# Access Compliance Report Public Rights-of-Way (Curb Ramps)

Main Street: N/A Cross Street: AMADO\_PL Location: N

ADA ID: RPRK211122132517 Ramp Type: Type 6 - Directional 1 Initial Pass/Fail: Pass Overall Compliance: No Severity Score: 7

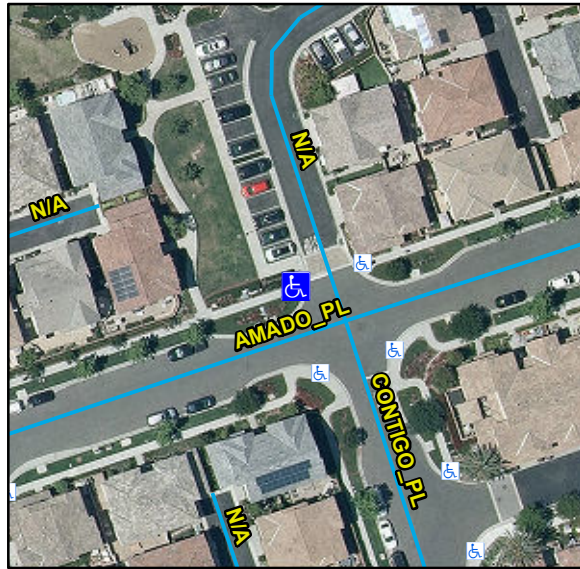
| Compliance | Description                   | Data       | Compliance | Description                   | Data    |
|------------|-------------------------------|------------|------------|-------------------------------|---------|
| No         | Grade Break                   | No         | Yes        | Flare Type RT                 |         |
| No         | Landing Cross Slope (%)       | 2.8        | Yes        | DWS Left Offset (in)          | 0       |
| No         | Gutter Run Slope (%)          | 6.2        |            | Road Cross Slope (%)          | N/A     |

Remove & Replace Entire Ramp. Remove & Replace Gutter.

R304.5.3, R304.5.2, R304.5.4, STD 1115
